# **Authorized Field Change**

AFC G-04908

Subject: CE Bus Models, Built at the Tulsa Assembly Plant, Between January 22, 2001 and July 14, 2004 with Air Brakes or Optional Air Compressor may have a Pipe Plug in the Air Governor Exhaust Port

Figure 1 Remove Pipe Plug from Exhaust Port (Arrow)

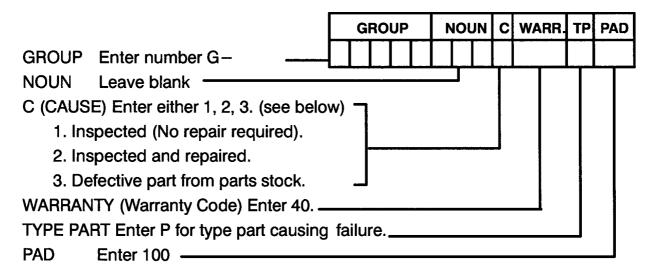
Certain 3000 CE Bus Models, built at the Tulsa Assembly Plant, between January 22, 2001 and July 14, 2004 with air brakes or optional air compressor may have a pipe plug in the air governor exhaust port. Removal of the pipe plug from the air governor will improve the service life of the air compressor.

1. Locate and remove the pipe plug from the air governor exhaust port (Figure 1).
